PRODUCT CHANGE NOTIFICATION

PRODUCT CHANGE NOTIFICATION NUMBER: PC000046

Shielded modular ethernet jacks.

Appendix A:

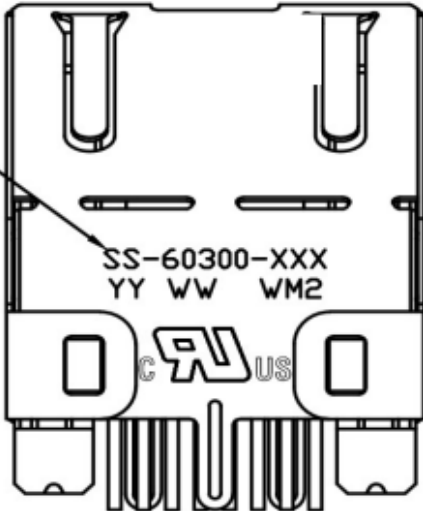
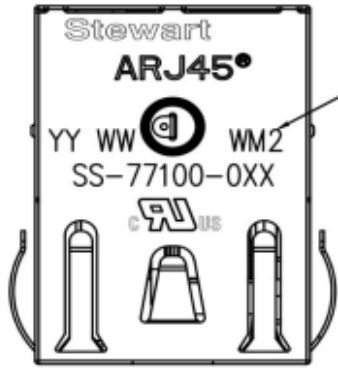
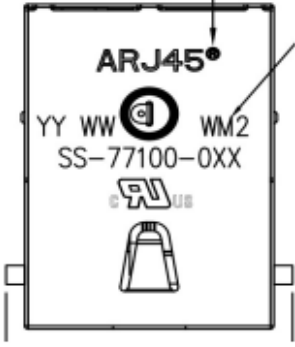
To improve efficiency, laser marking of shields with Logos, Date-Codes, Location of Manufacture, Part Number and appropriate UL symbol (when applicable) will be consolidated into a single process step. Currently, these markings are added at various production stages. The new method will result in all markings co-located on the same side of the metal shield as noted in Appendix A.
